Determination 2010/66

The provision of access and facilities for people with disabilities to a new building at the Emilia Maud Nixon Garden of Memories, Uxbridge Road, Manukau

Figure 1: the proposed building and routes between the floors

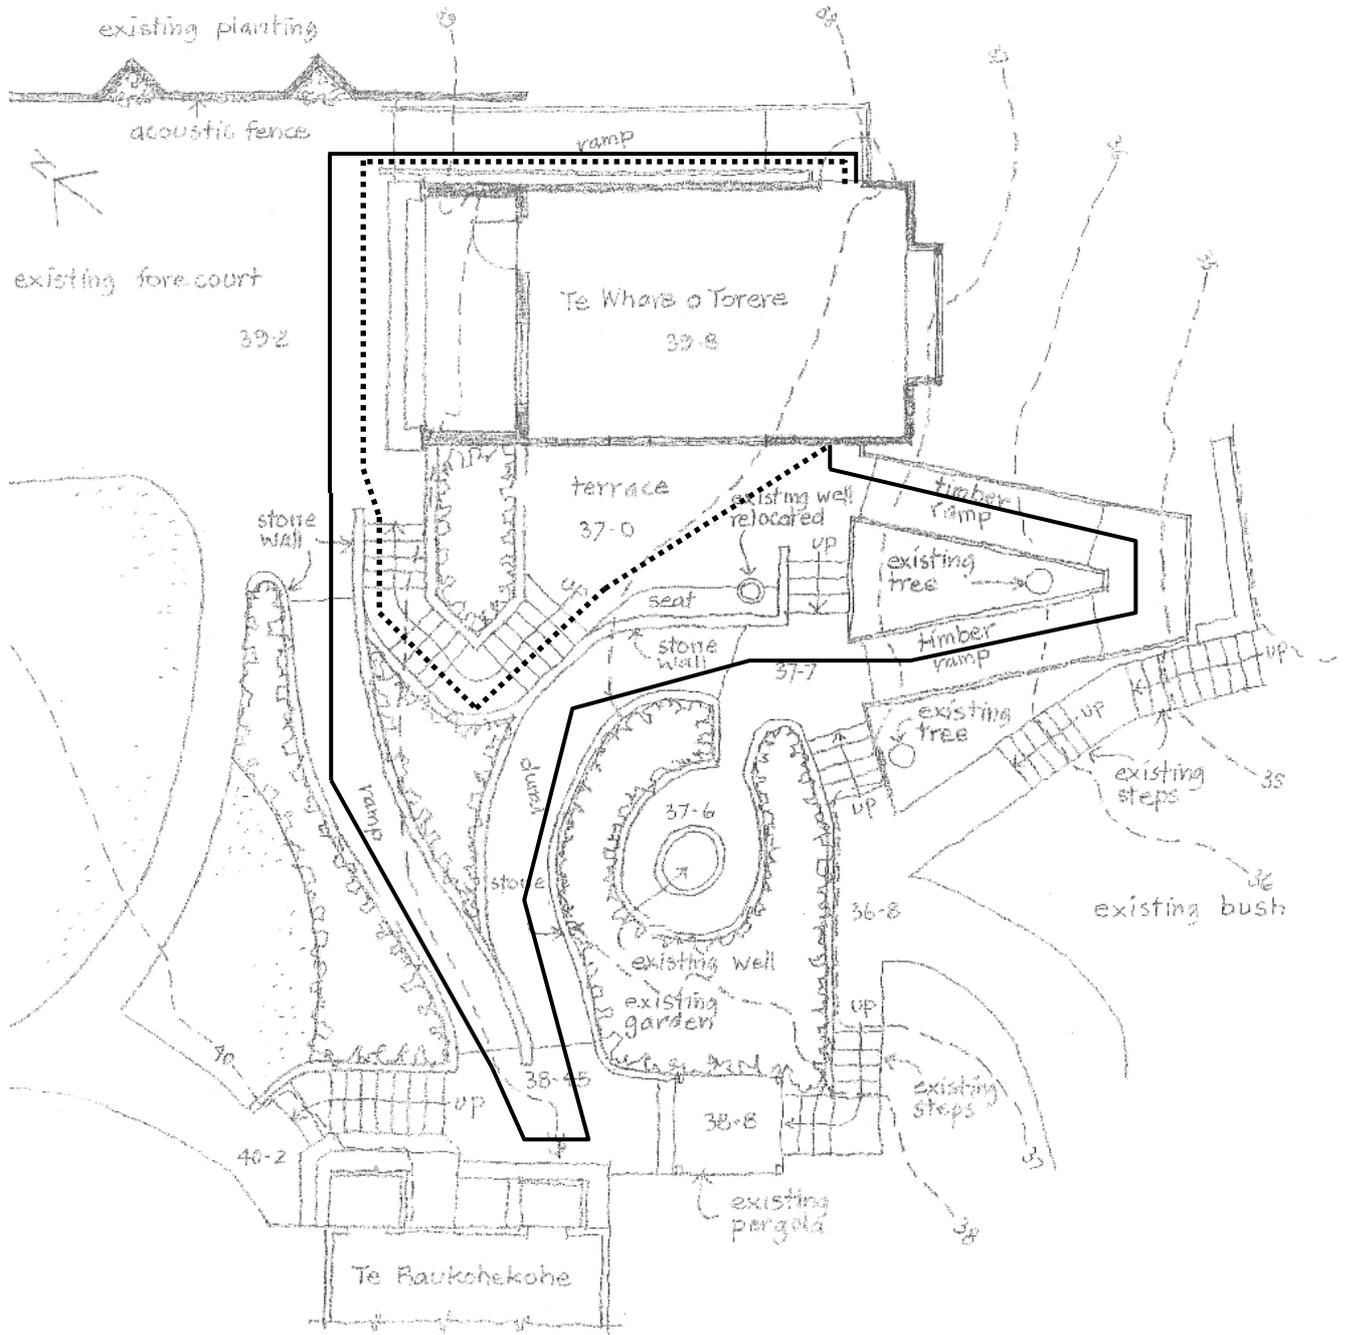
- 2.5 Ramps are proposed to be built to provide an accessible route between the exhibition and teaching space on the upper floor and the toilets on the lower floor. The ramps are approximately 58 metres long, made up of approximately 36 metres of 1:12 sloping ramps and 22 metres of flat areas and landings. Figure 1 shows the proposed building and the routes between the upper and lower floors of the building.

The wheelchair access envisaged clearly fails to meet legal requirements ... From the assembly area upstairs, a paraplegic would have to cope with a 60-plus metre access-way which includes five ramps, two of which are curved and separated by a hairpin bend. Another two, around and under a 70 year old kahikatea tree, are also separated by a very acute bend. They are to be made of timber and as they would be wet for a great deal of time in winter and spring would cause anyone in a wheelchair a great deal of trouble trying to get traction or in braking.

- G1.3.3 – ‘Facilities for personal hygiene shall be provided in convenient locations.’
- 5.3 D1/AS1 is silent on curved ramps, however, the expert noted that curved ramps place additional physical demands on a person controlling a wheelchair, and these demands must be compensated for in the design of a curved ramp. NZS 4121³ states ‘If a curved or circular ramp is provided it needs to adequately address the relationships of gradient, radius and width.’ The expert was of the view that while the top curved ramp was of a gentle gradient the design of the lower ramp was not adequate as it has a tight turn at the bottom end.

- 5.4 The expert noted that there are no specific requirements for the route to be covered, however, with respect to the slip resistance of the proposed ramps adequate slip-resistant walking surfaces are required under all conditions of normal use. The expert was of the view that the conditions of normal use to be considered in this case includes the shading provided by the surrounding vegetation and proposed building, the exposure to the elements including rain, the build-up of vegetation litter and algal growth on the ramps, the removal of surface moisture, and the ability of the ramp surfaces to dry out under natural conditions.

- 5.5 The expert noted that neither Acceptable Solution D1/AS1 nor compliance document NZS 4121 place specific limitations on the maximum length of an accessible route. However, the proposed accessible route provides neither safe nor easy movement as required by the performance requirement Clause D1.2.1.

- 5.6 The expert also noted that the accessible sanitary facilities have not been provided in a convenient location in accordance with Clause G1.3.3.
- 5.7 Therefore, the expert found that the proposed accessible route did not meet the requirements of Clauses D1 and G1.

- 6.9 I note the comments of the expert, who is of the view that a person in a wheelchair would face difficulties in traversing the 58 metre proposed accessible route. The difficulties include the ease of use of the proposed accessible route, which is an exterior route and unprotected from the weather, and the time required to travel to and from the sanitary facilities because of the length of the route that is required to be made up of ramps with a 1:12 maximum slope that cover a vertical distance between the floors of the building of 2.8 metres.

- 6.10 I am of the view that the accessible sanitary facilities are therefore not in a ‘convenient location’ in accordance with Clause G1, because of the difficulties that would be faced in traversing the proposed accessible route.

- 7.1 In accordance with section 188 of the Act, I hereby determine that the proposed building does not comply with Building Code Clauses D1 and G1, and therefore I reverse the decision of the authority to issue a building consent.
